**RE: 120 – 128 HERRING ROAD, MACQUARIE PARK
MP09_0218 – BUILDING A S75W MODIFICATION**

ARBORICULTURAL ASSESSMENT – BUILDING A

S75W Proposal for Approved Development:

Stage 1 Works, 120-128 Herring Road, Macquarie Park, NSW

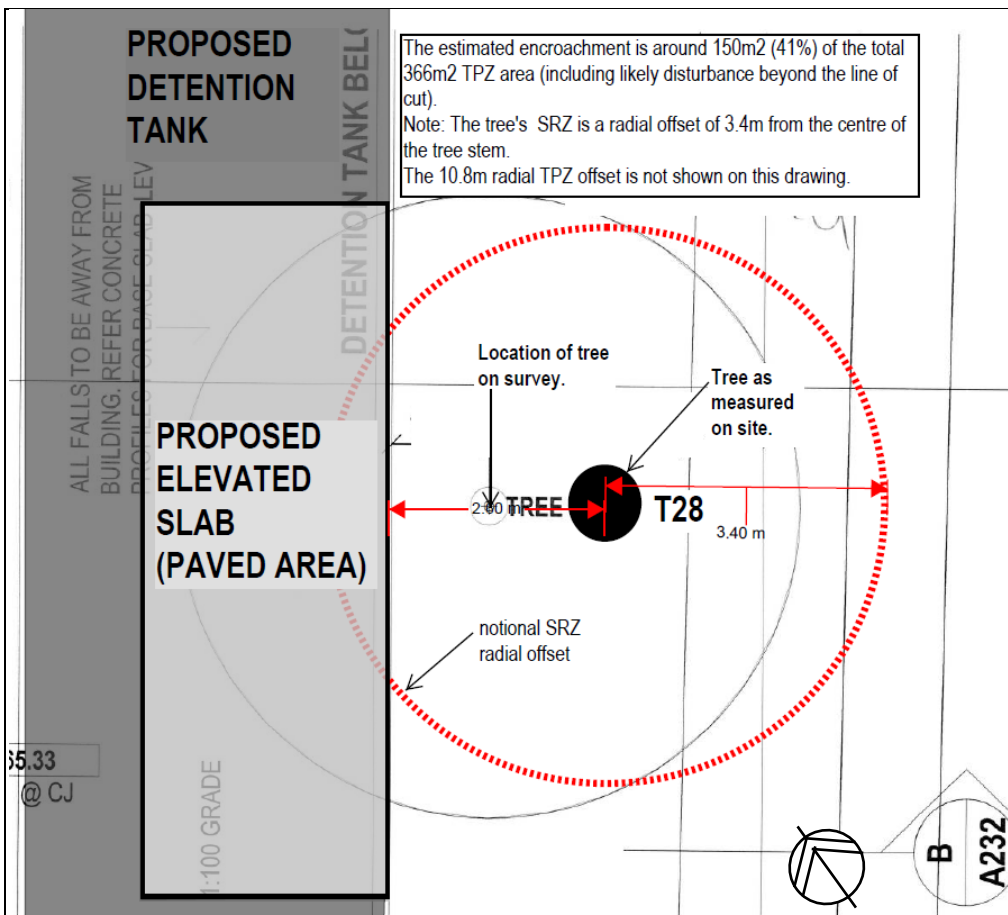
This tree has a DBH of 800mm. Its SRZ is a radial offset of 3.2m. Works identified in the SRZ are a strip footing for a planter at the east side of the building and a pedestrian path providing access to Herring Road (Figure 1, page 7).

19. Tree 27 – *Cupressus macrocarpa* (Monterey Cypress)
This tree has a DBH of 900mm. Its SRZ is a radial offset of 3.4m. Works identified in the SRZ are a strip footing for a planter at the east side of the building (Figure 1, page 7).

20. The proposed footing extends more than 1m into the tree's SRZ, and for a distance of 5m or so across the SRZ. There is a distinct possibility that woody anchor roots would be present in the SRZ area projecting into the planter wall footprint.

25. Figure 2, page 7 illustrates the amended footprint of the approved OSD (as per arboricultural advice) to avoid bulk excavation within the tree's notional SRZ. The proposed elevated paving slab is, in theory, the only SRZ encroachment, although the slab could be constructed to avoid any conflict with woody roots encountered at construction stage. UFA notes an existing low concrete wall at the base of the tree on its east side has likely constrained woody root growth in this east direction to some degree. Subsequently, significant anchoring roots are likely to extend further west than the notional 3.4m offset and be well within the footprint of the proposed elevated slab and possibly within the proposed excavation for the OSD.

37. Tree 26 (Scribbly Gum) – Retain and protect.
- Path construction above the existing ground level (no excavation for path within the SRZ).
 - Prior to construction the project arboriculturist is to investigate the location of significant roots potentially affected by planter wall construction (e.g. root mapping, via hand digging or Air-spade®).

39. Tree 28 (Scribbly Gum) – An AQF Level 5 arboriculturist is to supervise the OSD and elevated concrete slab works undertaken within 8m radius of the tree, and provide advice in regard to any other works (e.g. landscape hardworks, ground level changes, etc) that may have potential to harm the tree.

Plate 1 Looking NE to Tree 27, illustrating the estimated removal of crown to accommodate the unit terraces and pedestrian clearance beneath the tree (red shaded area). The projected removal is likely to be much greater if construction scaffolding is erected (yellow area).

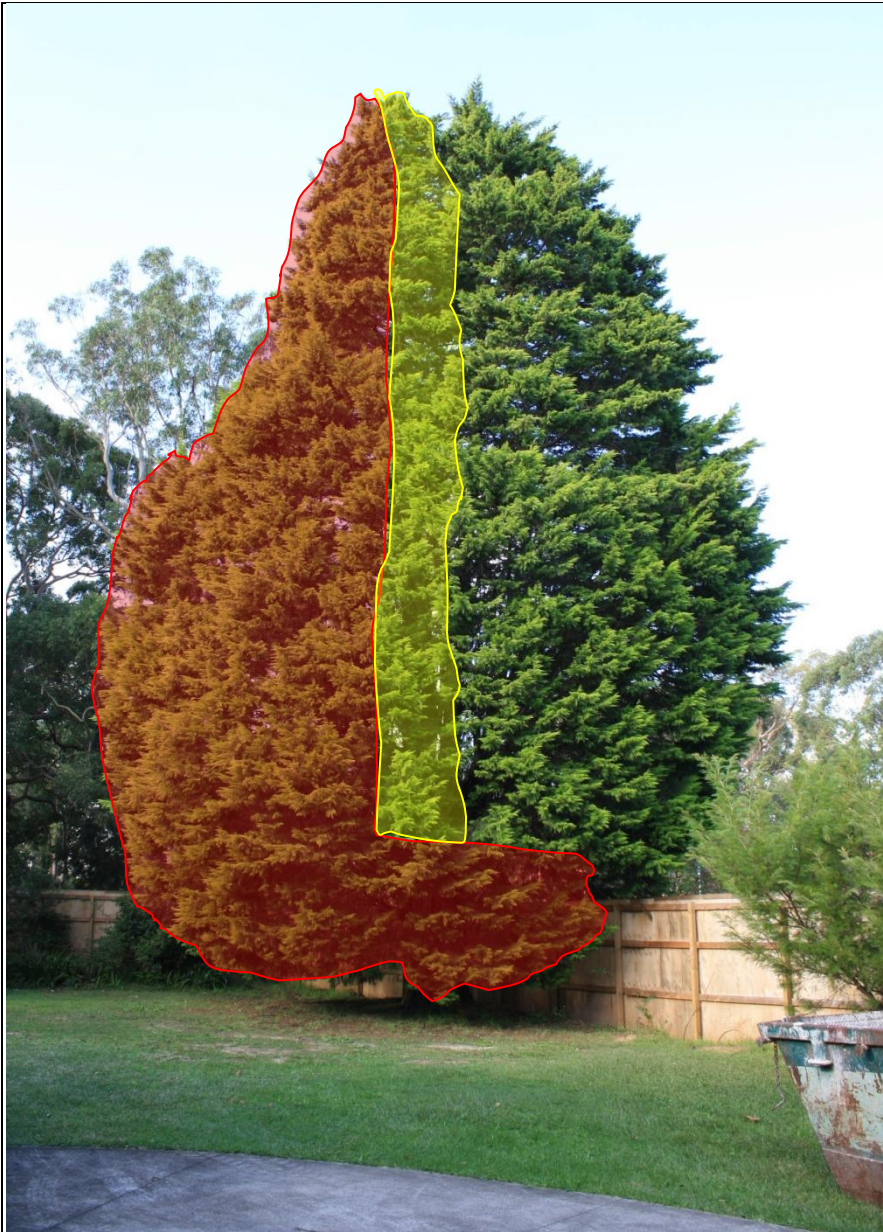
22. The tree will also require excessive pruning to lift the crown of the tree on its north, west and south sides to enable pedestrian access around the building and to clear the terraces of units facing the east. The terraces are approximately 2.2m from the centre of the tree. Construction scaffolding will reduce this setback to the tree to a point almost directly over the main stem. See Plate 1, page 8 for a schematic estimate of crown loss from pruning.

23. Pruning of the tree will potentially remove up to 60% of the current foliage, expose the bare, 'internal' frame of the tree, which is highly unlikely to generate new growth, and drastically affect the natural form of the tree.

- Planter wall construction is to adopt appropriate methods to avoid cutting of any roots identified to be retained by the arboriculturist.
38. Tree 27 (Monterey Cypress) – Remove, due to unacceptable impacts on TPZ, crown structure and tree form.
